PROJECT: LOMBARDY PUBLIC SCHOOL PARKING, SEPTIC
AND SITE WORKS - PHASE 2 MECHANICAL AND
ELECTRICAL UPGRADES

ADDENDUM No.: 02

PROJECT No.: 209-00237-00

DATE: 2026-04-28

SHEET NUMBER:	AR-D-501
SHEET #	- OF -
ISSUE:	ISSUED FOR ADDENDUM 02
DATE OF:	27 APRIL 2026

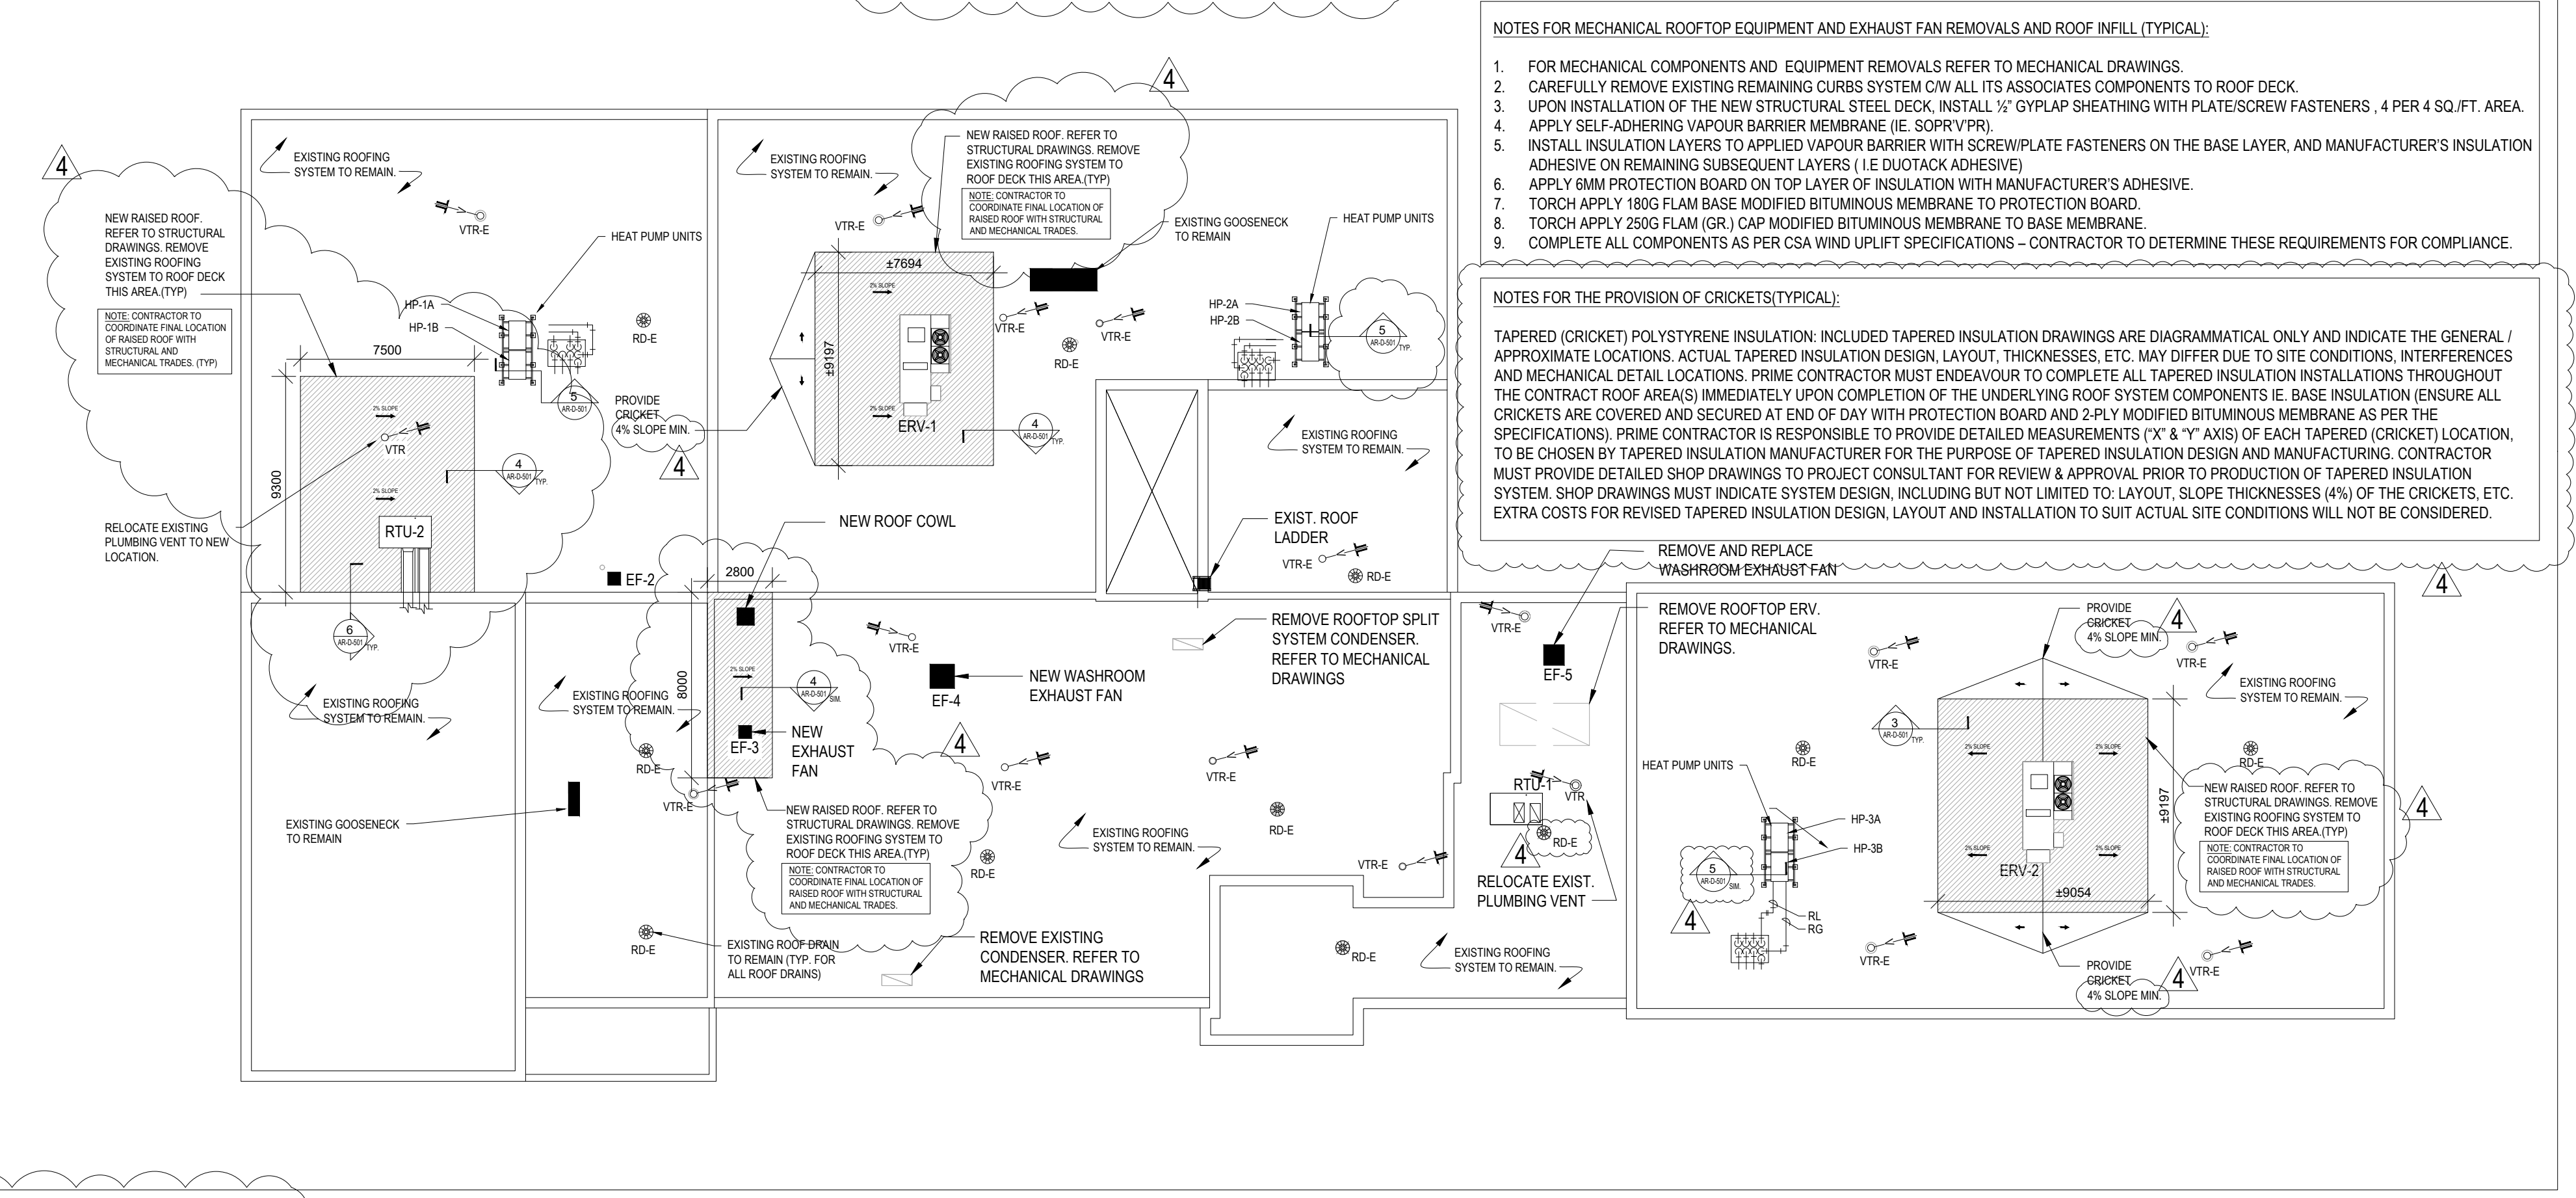
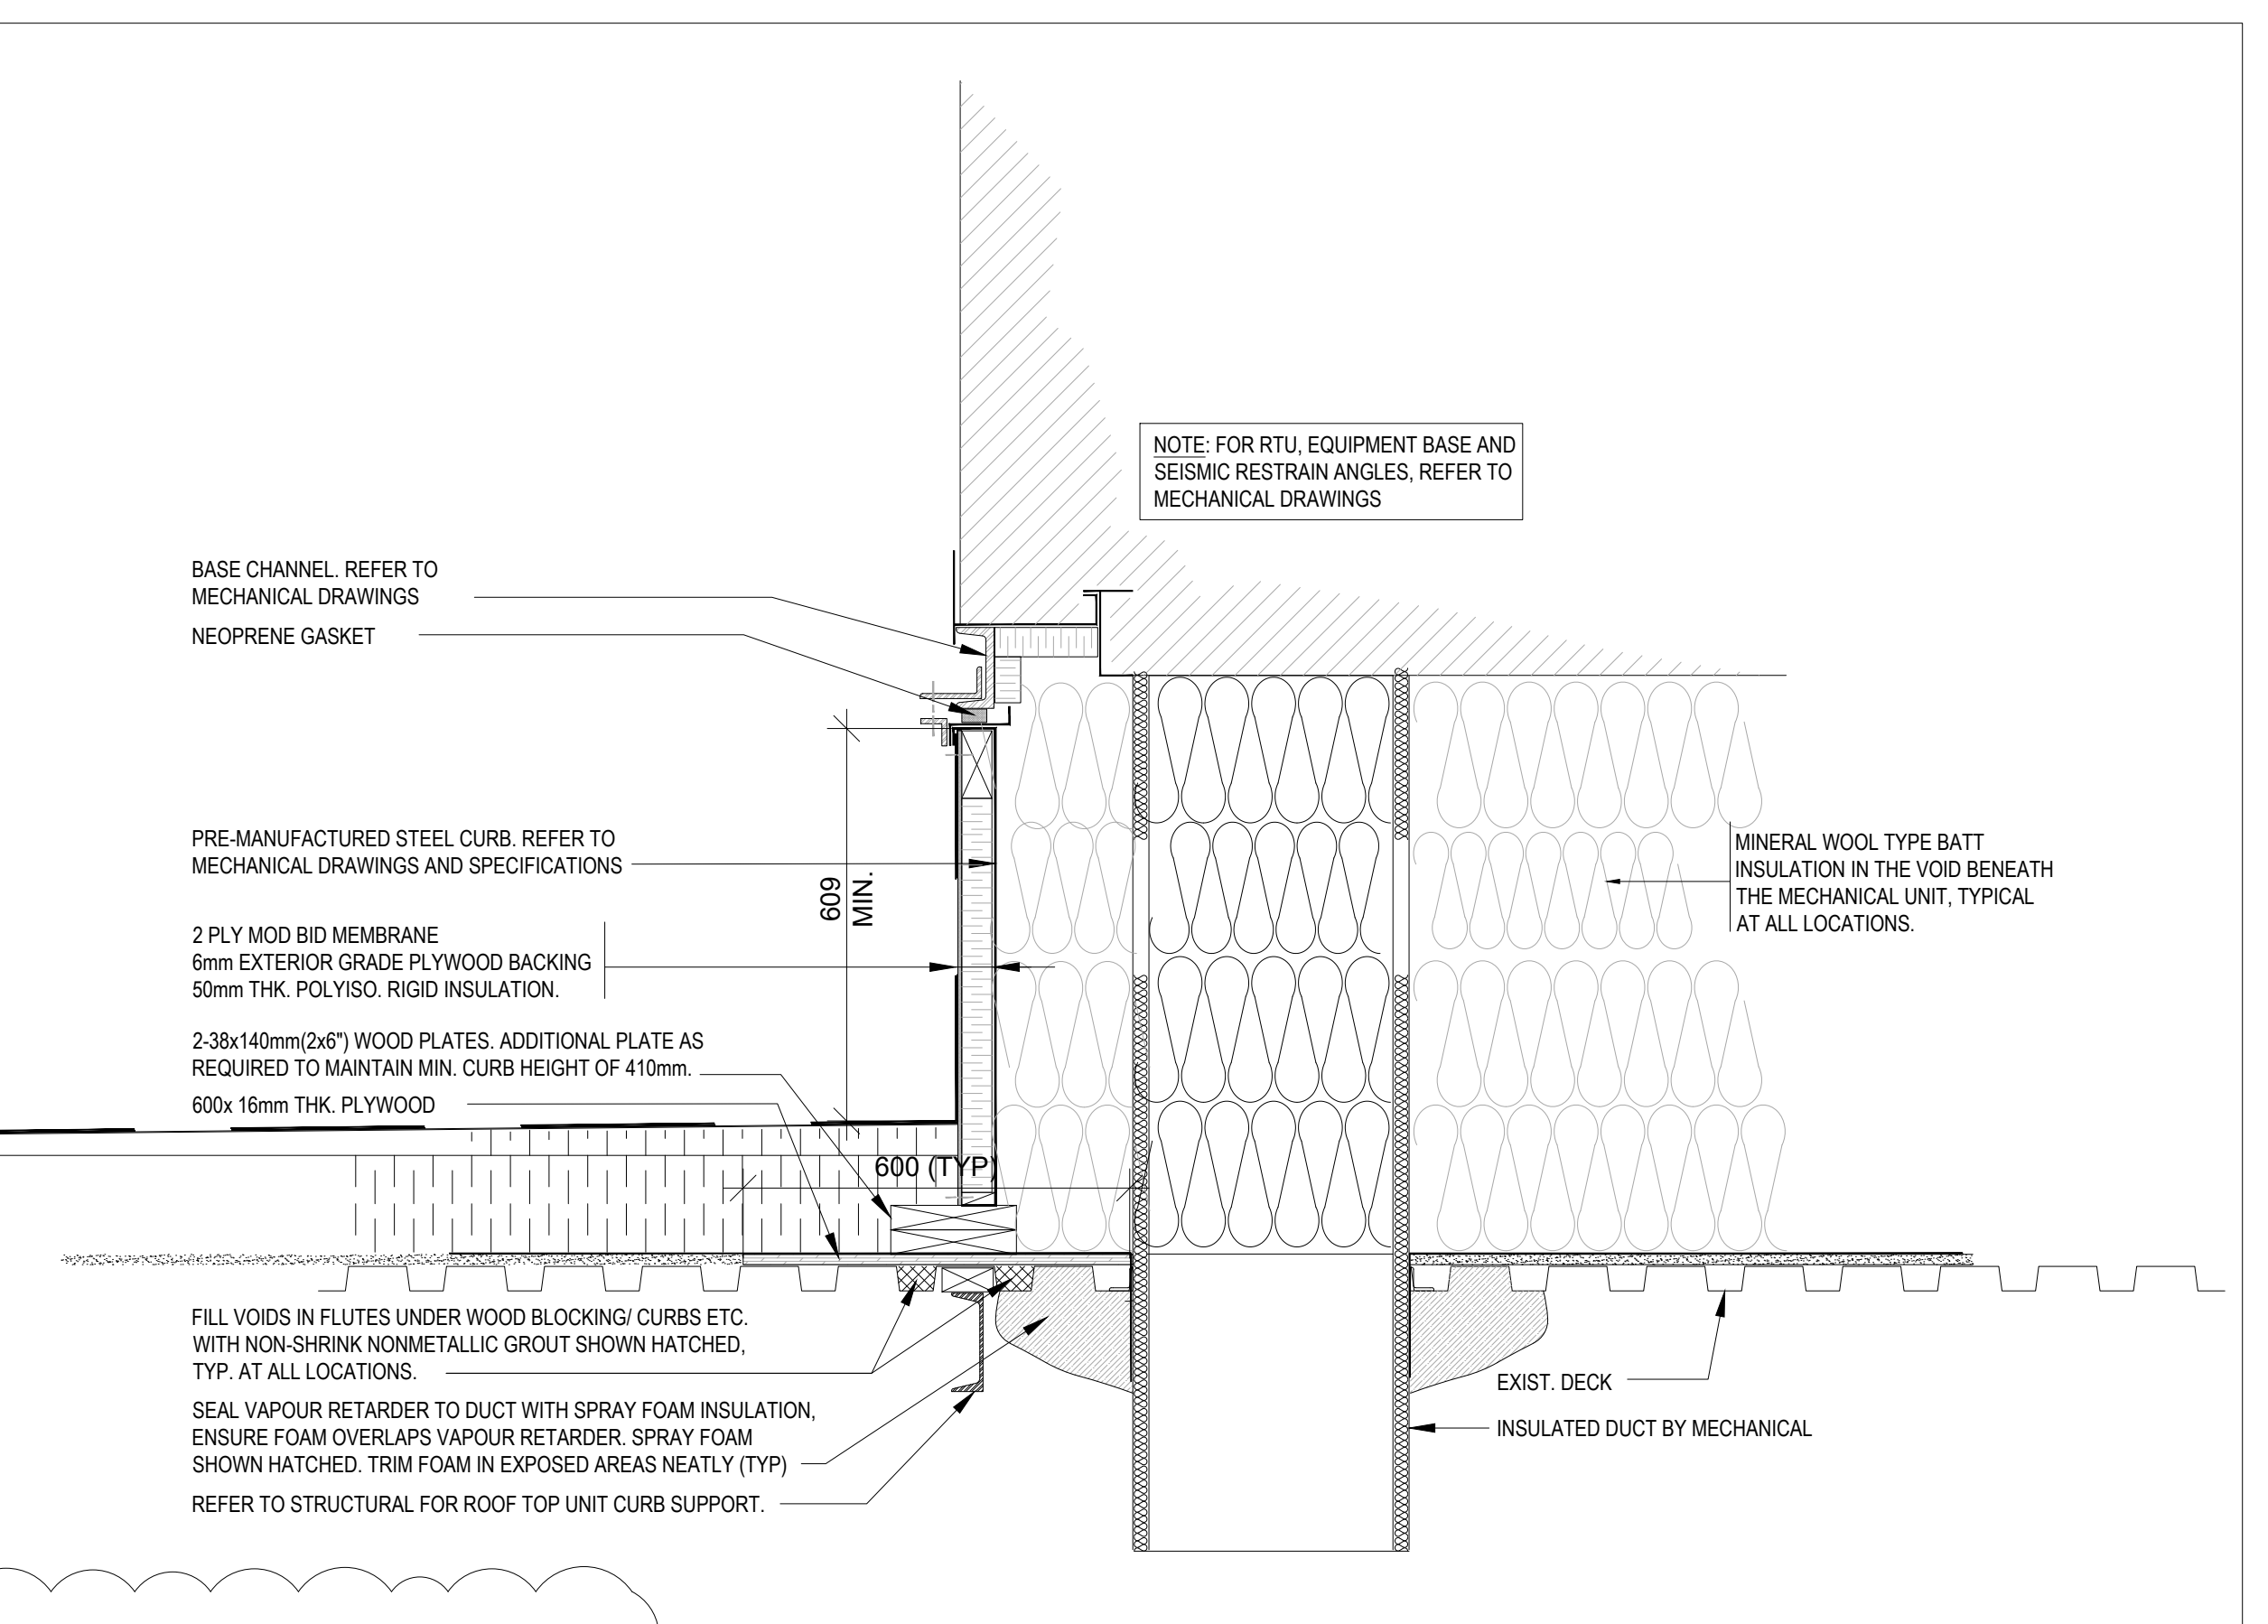
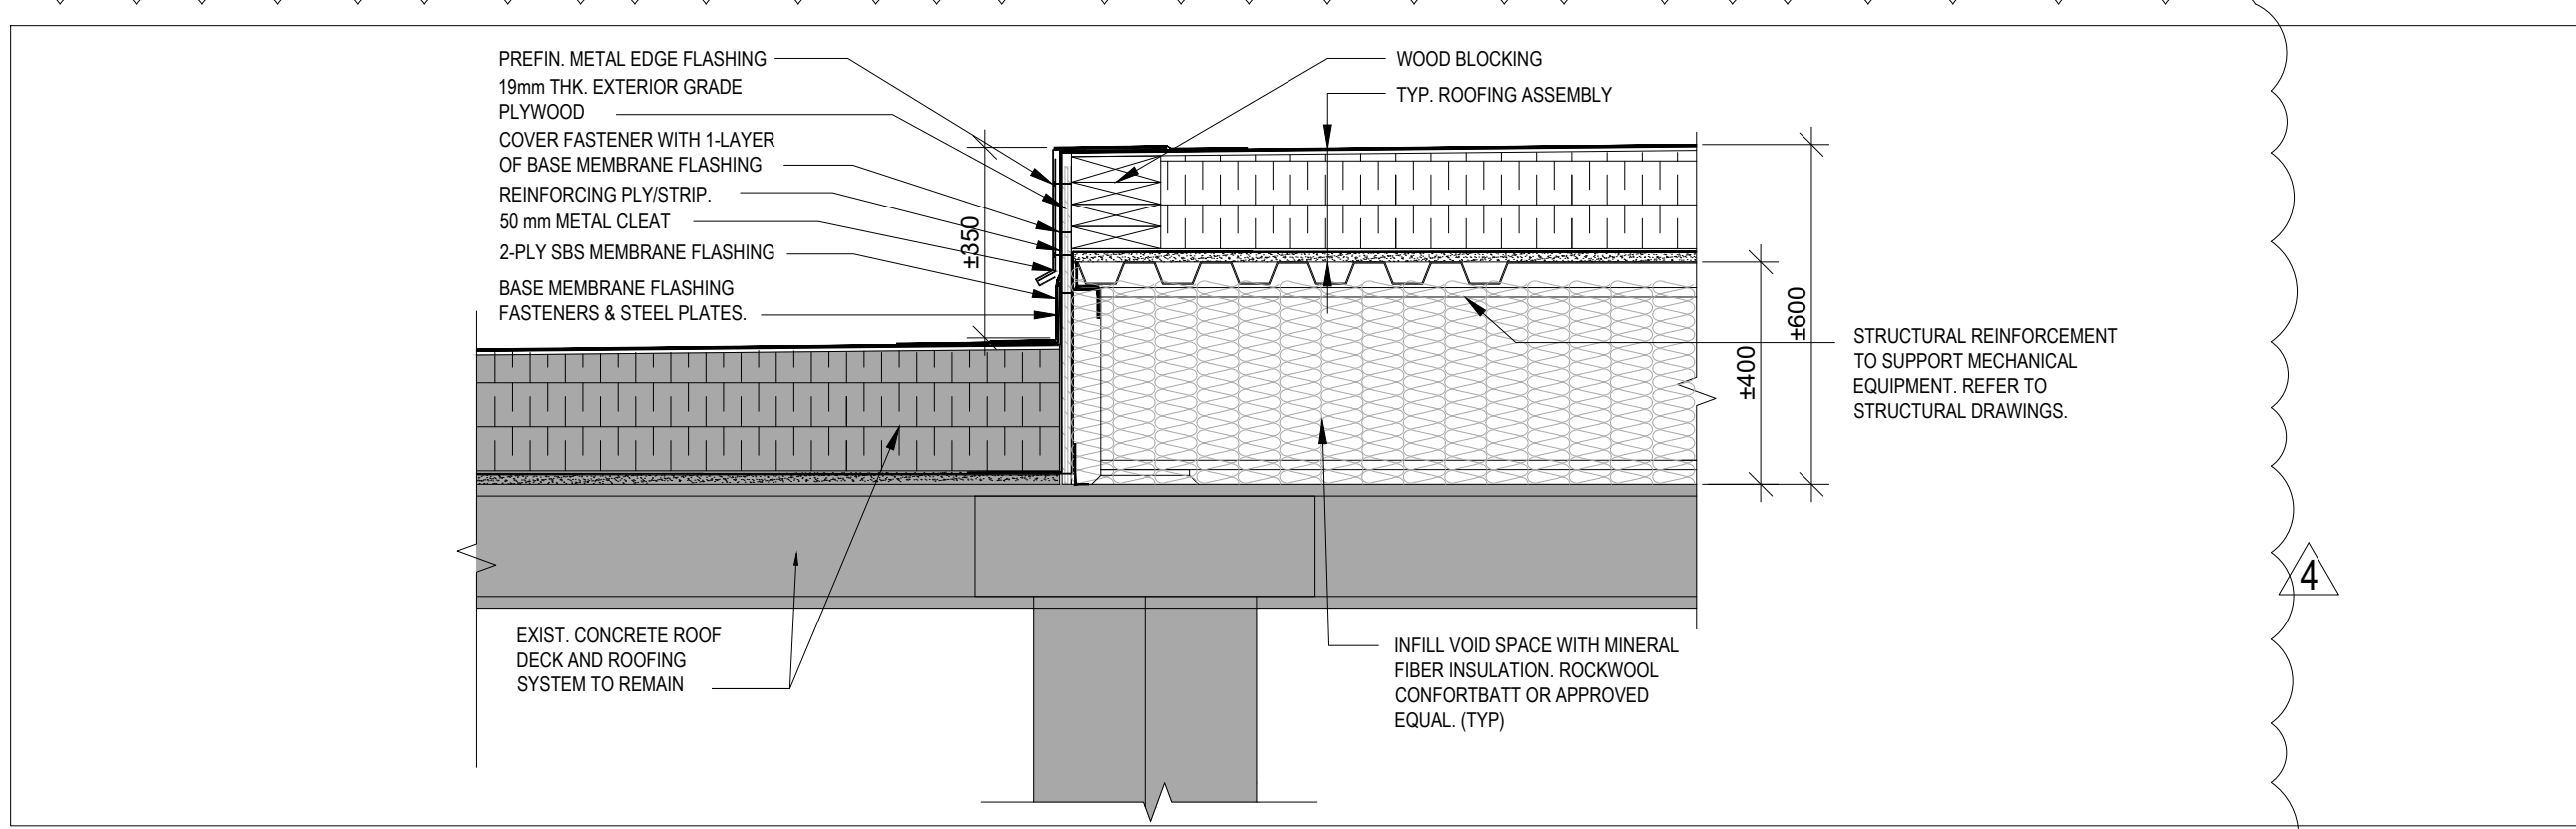
AR-D-501 ROOF PLAN AND DETAILS

1. Detail name and number added.
2. Detail dimensions added
3. Details 5 & 6 added
4. Modifications and added notes on the roof plan
5. Note added for provision of "crickets"
